Docket Number:	21-AFC-02
Project Title:	Willow Rock Energy Storage Center
TN #:	248126
Document Title:	Defenders of Wildlife Comments on Willow Rock Energy Storage Center Set 2
Description:	N/A
Filer:	System
Organization:	Defenders of Wildlife
Submitter Role:	Public
Submission Date:	12/16/2022 1:43:23 PM
Docketed Date:	12/16/2022

**Defenders of Wildlife Comments on Willow Rock Energy Storage
Center Set 2**

RE: Willow Rock Energy Storage Center; Docket Number 21-AFC-02

U.S. Geological Survey Topographical Map

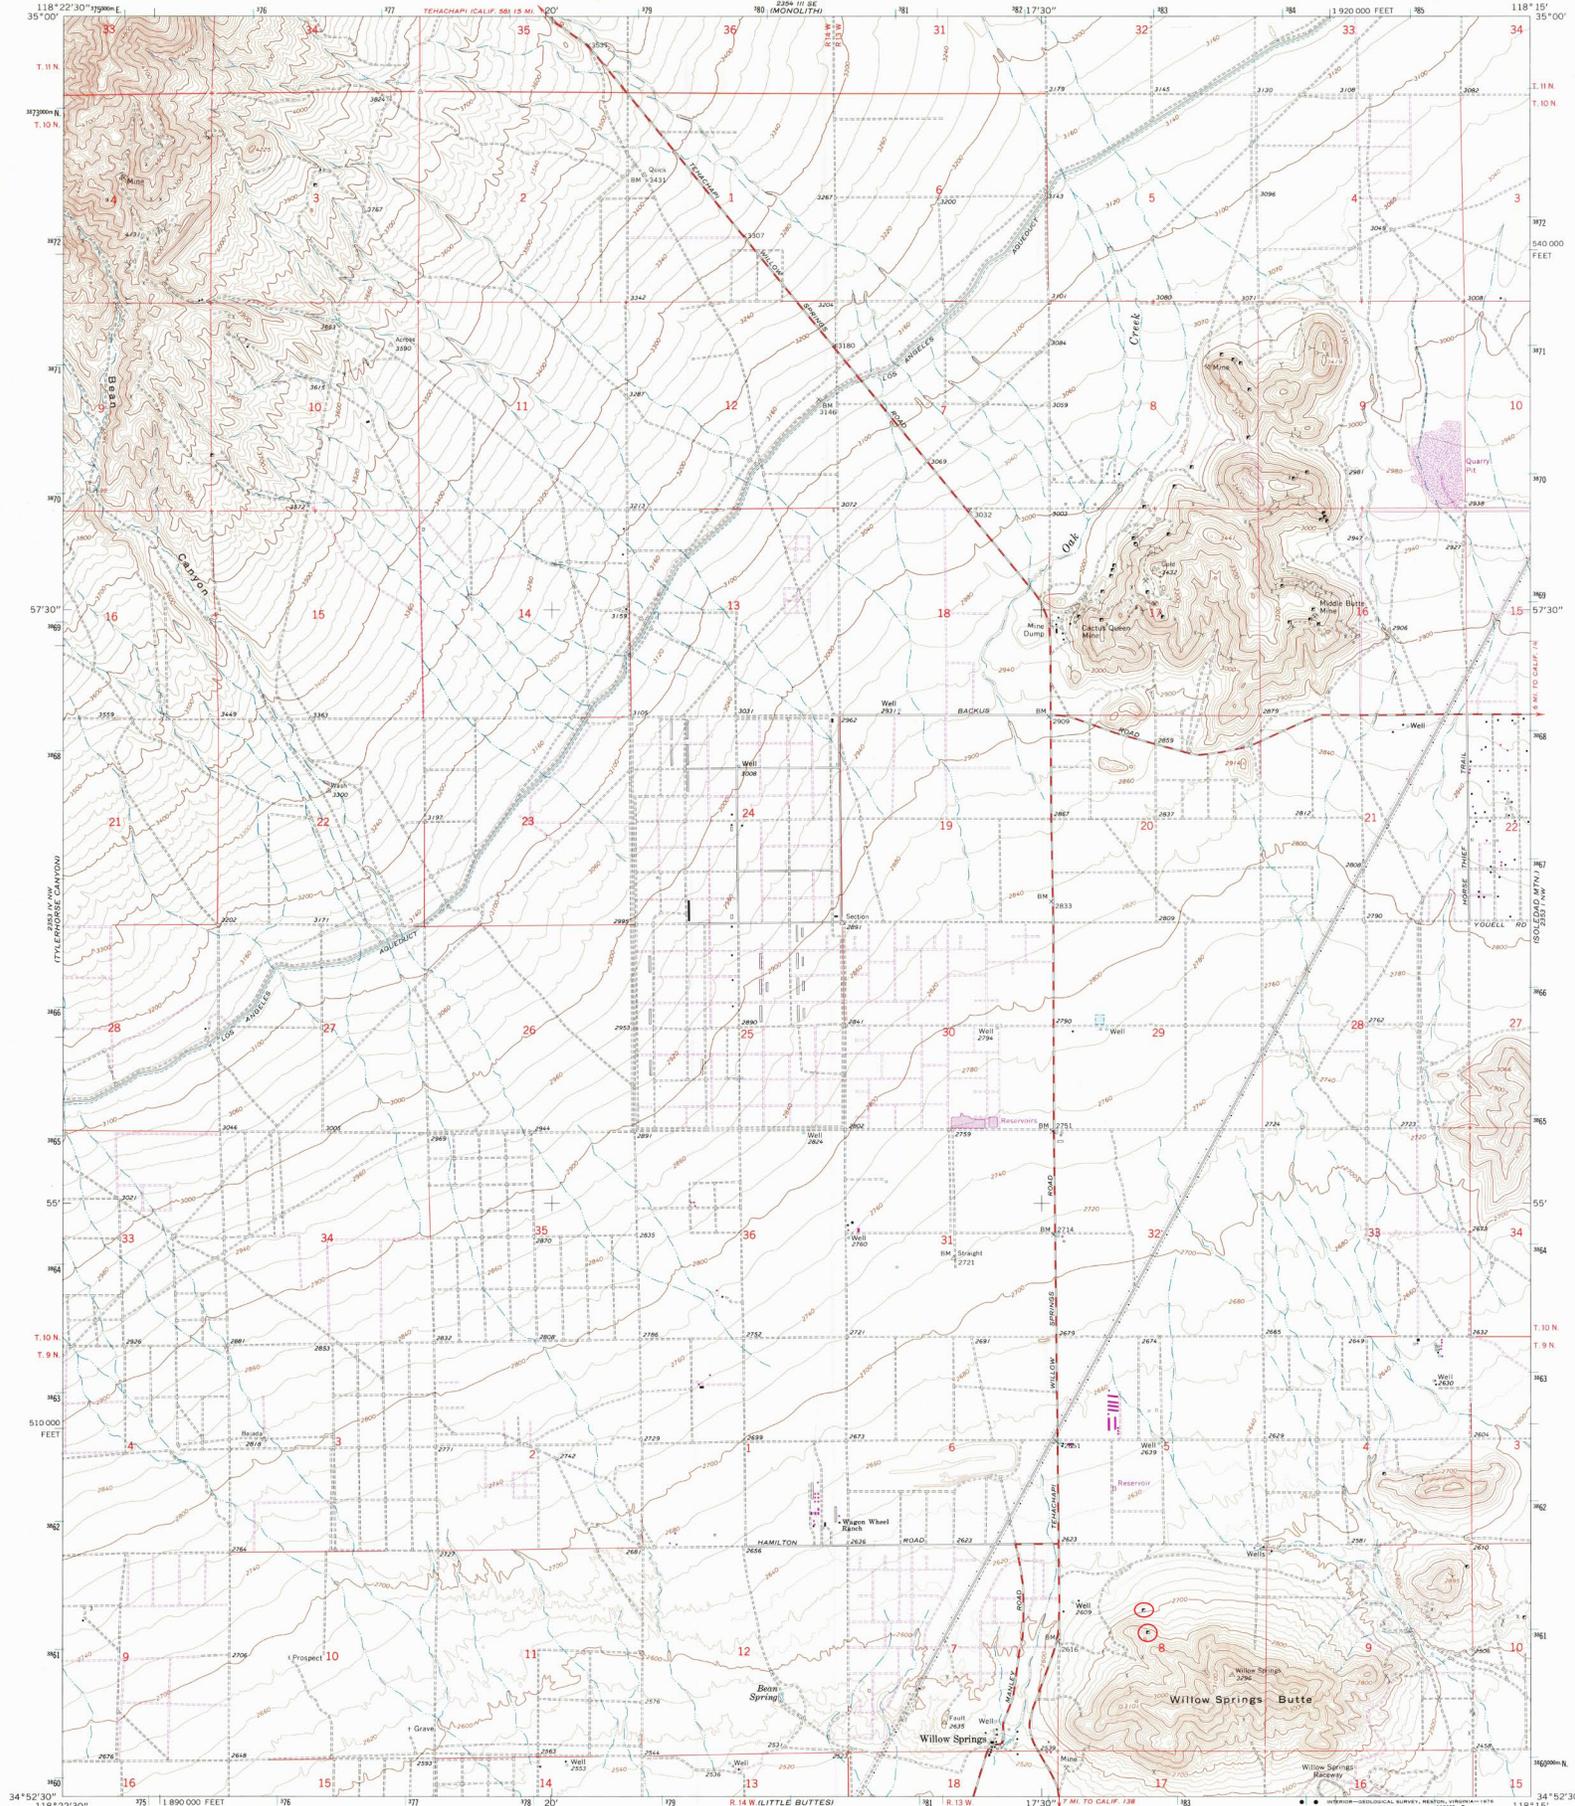
2. **Failure to survey for bats:** As review of the attached U.S. Geological Survey topographical map shows, that there appears to be two open mine shafts south of the Project site boundary, including one mine shaft that is approximately 350 feet from the site. Blasts from the project could disrupt roosts if they are present in the mine shaft. As CDFW noted in its August 31, 2022, letter to the CEC, the project applicant should conduct surveys for bats within the Project and within at least a 500-foot buffer.
